Re: Moos Tract

MDP # 848

The City Staff Development Review Committee has reviewed Moos Tract Master Development Plan **M.D.P. # 848**. Please find enclosed a signed copy for your files. Your plan was accepted however please note the following:

MASTER DEVELOPMENT PLAN
 for
MOOS TRACT

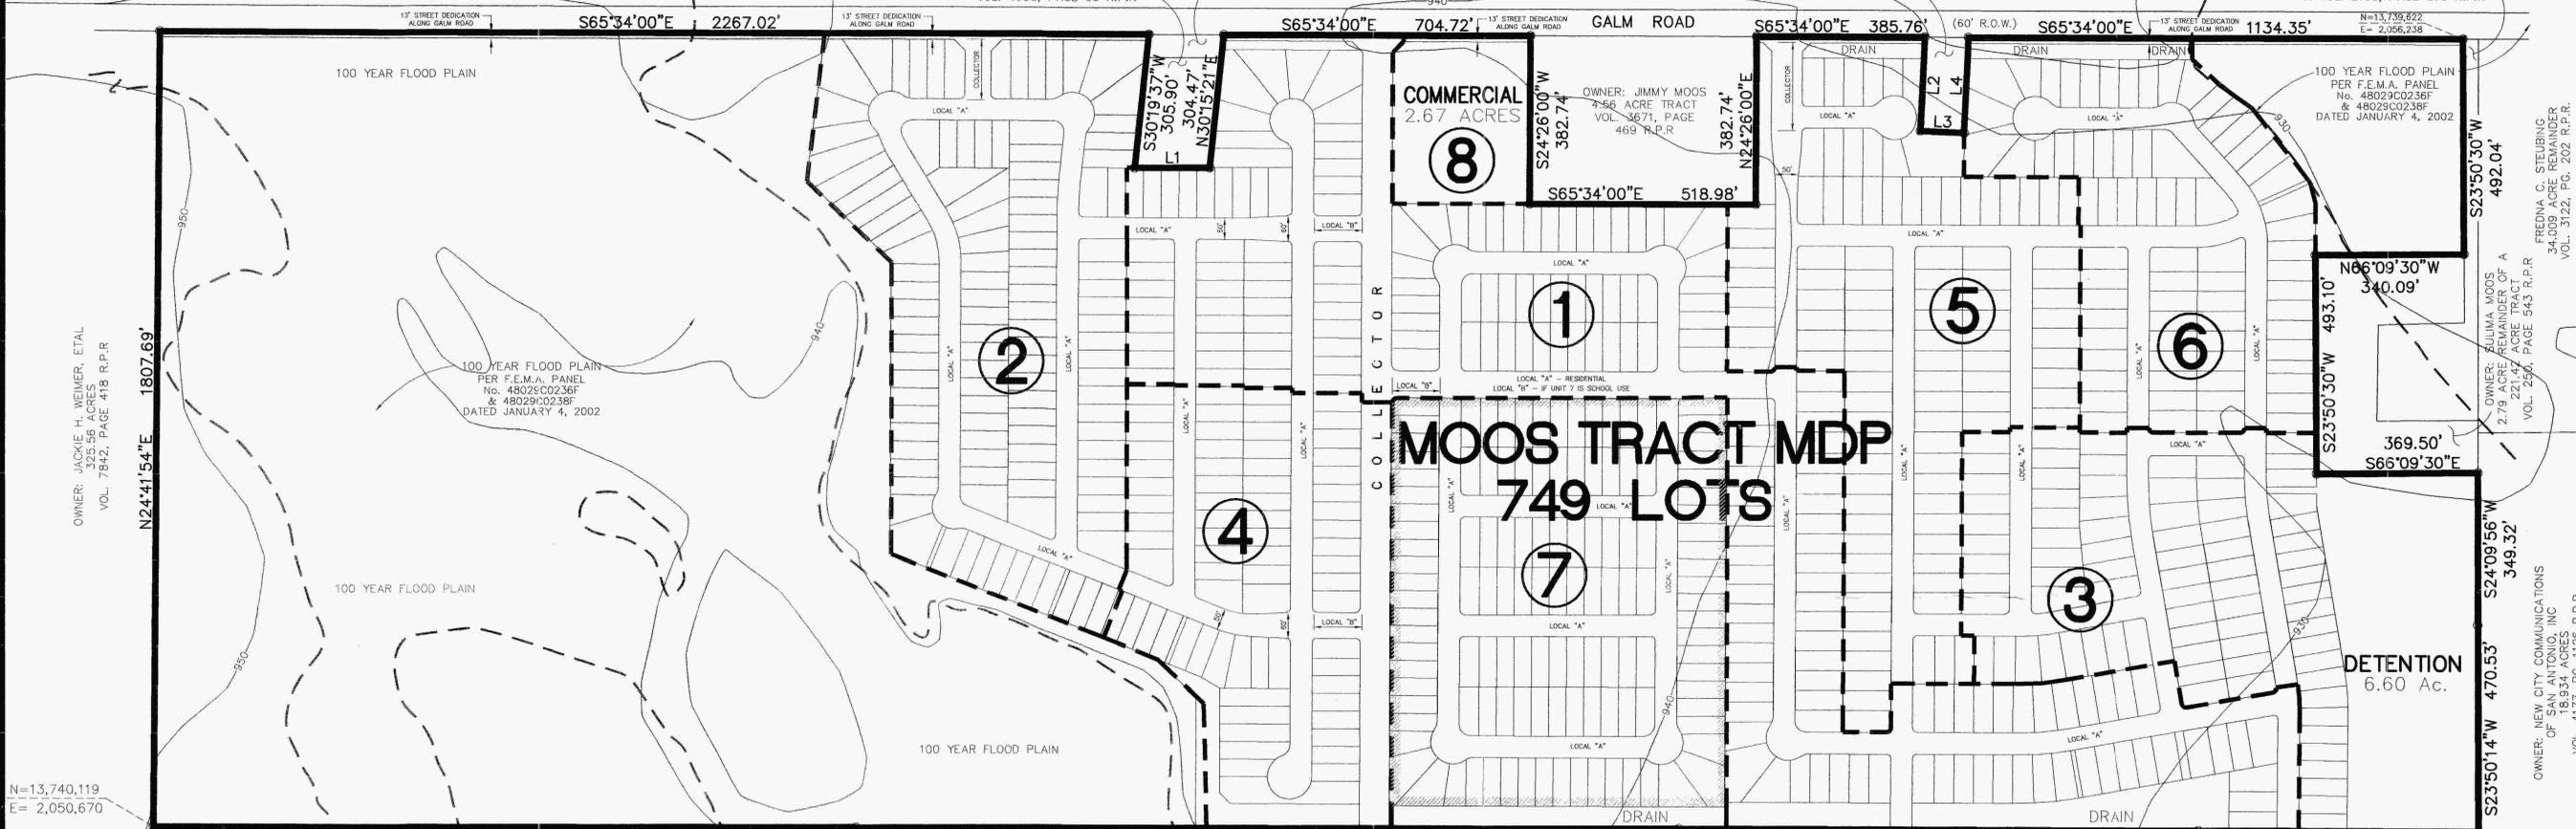
- In consideration of public safety and convenience, excessive grades by reason of topography should be avoided in street layouts and arrangements.
- Any access and R.O.W. issues along state facilities will need to be resolved with the **Texas Department of Transportation (TXDOT)**. For information about these requirements you can contact TXDOT at 615-5814.

- **DSD – Traffic Impact Analysis & Streets**
 - All roadways shall conform to UDC 35-506(c)(1), Table 506-1: Functional Classification System Description

- All commercial driveways for this project shall comply with UDC 35-506, (r) Access and Driveways
 - Provide clear sight distance at each roadway/driveway to provide adequate distance for obstruction free viewing distances for approaching traffic. All signage, landscaping and improvements should be selected and located so as not block these clear sight distance areas.

- Galm Road. The developer shall construct sufficient left and right turn storage lanes with a bay taper and transition as it relates to the submitted TIA analysis.

- **Bexar County** – the following is recommended to be provided by the developer prior to completion of the Moss Tract Subdivision:
 - Provide westbound left turn storage on Galm Road at all three access point into this subdivision

- Provide an eastbound right turn deceleration lane for the main collector entry
 - Coordination with Bexar County Capital Project Section should be made to include the design of all auxiliary lanes on Galm Road

- Traffic controls shall be warranted as per the Texas Manual on Unified Control Devices and approved by Bexar County
- It will be expected that you will plat all of the property depicted in your Master Development Plan (M.D.P.) to include floodplains, drainage areas and open space.
